AUDIO SERVICE

BULLETIN NO.: 05-84

DATE: May 1984

SUBJECT: A-960 Amplifier

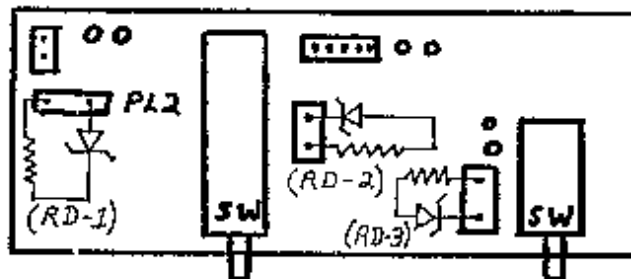
PROBLEM: Power won't come on, circuit checks out normal

CAUSE: Burnt out lamp in "Power" switch button, also in "Main Direct" or "Disc" button when switch is activated.

REMEDY: Replace burnt out lamp(s) and modify lamp circuit.

MODIFICATION: Solder a 22 ohm 1/4W resistor in series with a 10 volt 1 watt zener diode to connector pins shown on diagram as RD-1, RD-2, and RD-3.

PARTS: Lamp(s) (10.5V 80ma) part number JB000920 or equivalent.

Resistors (3) 22 ohm 1/4 watt or 1/2 watt *FLAME PHOTO*

Zener Diodes (3) 10 volt 1 watt
